From: Jones, William V., EMNRD
Sent: Tuesday, March 27, 2007 7:48 AM
To: Bill E. Prichard
Cc: Ezeanyim, Richard, EMNRD; Kautz, Paul, EMNRD; Williams, Chris, EMNRD; Sanchez, Daniel J., EMNRD
Subject: SWD Application: Matador 5 Federal #1 API No. 30-025-31056 Lower Yates Commercial injection Well

Near Capitan Reef
Denied

Injection Permit Checklist 2/8/07

APPLICATION FOR AUTHORIZATION TO INJECT

Attachement A

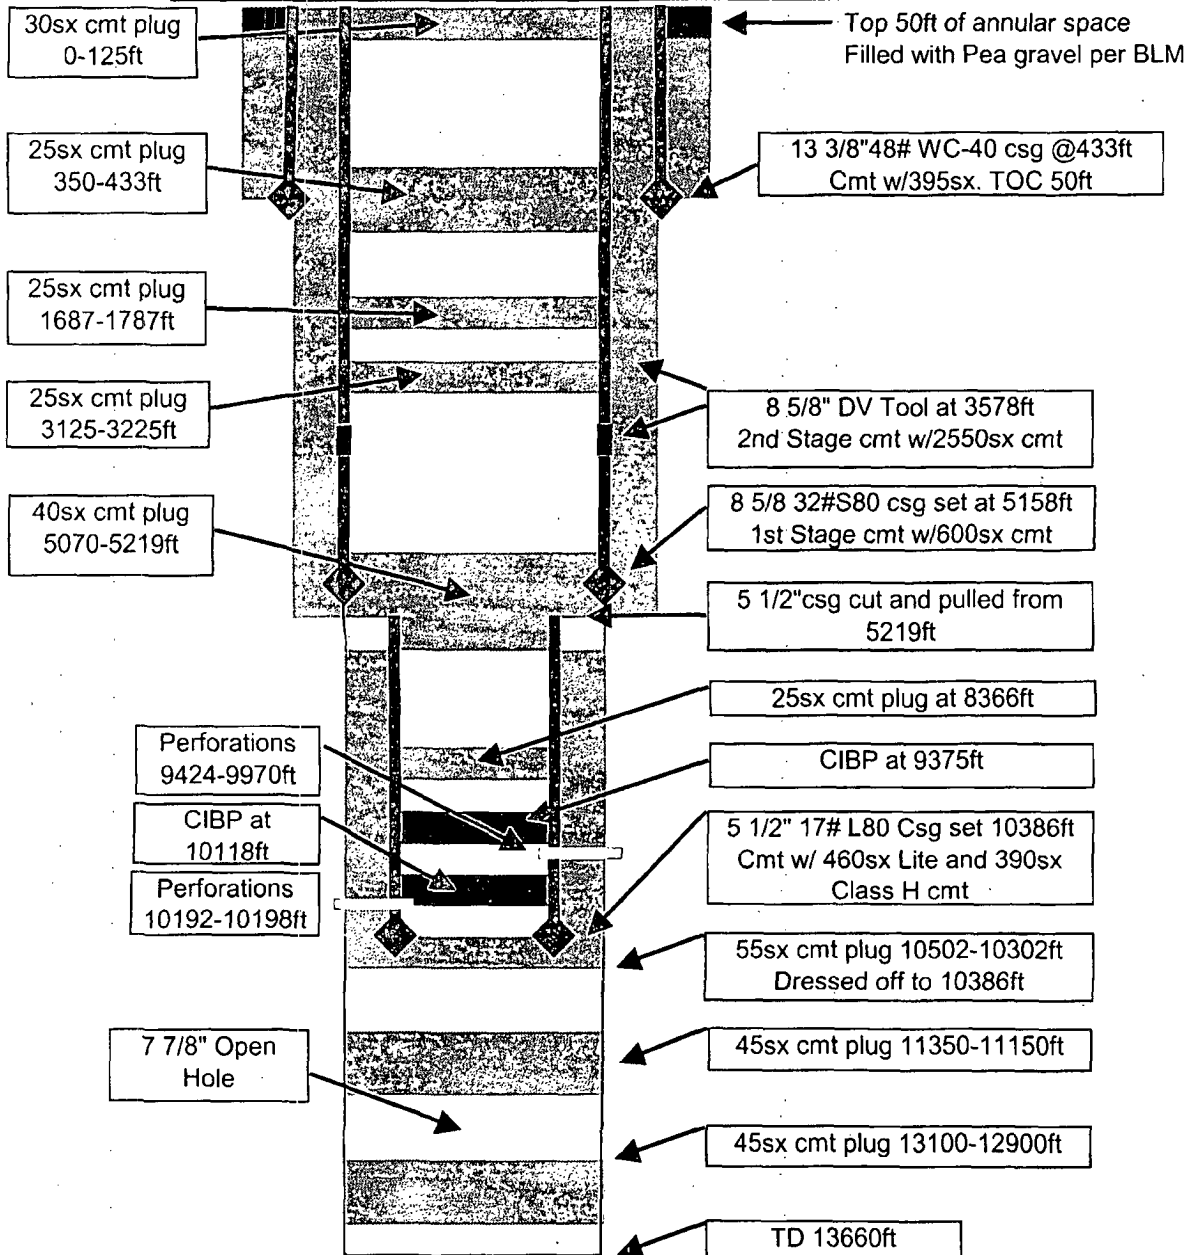
- 1) Notice to Cimarex not included.
- 2) the well would need a CBL on the 8-5/8 inch casing to identify the Cement Top below the DV Tool. Mark Fesmire has instructed that all open areas without cement in AOR wells or injection wells would require the application to be processed after notice and examiner hearing.
- 3) A shallower CIBP would be required within 200 feet of the intended injection interval.
- 4) You did not include Judah Oil's Rule 40 status.

→ CMT DID NOT CIRC
on Bottom Stage
(1600 PSI)
400 SX Halliburton + 200 H
(4530 FE)
746 PSI Max. WHIP
NO Open Hole (Y/N)
NO Deviated Hole (Y/N)

See CIBP 8 5/8" @ 4500', Run CBL on 8 5/8" casing!!
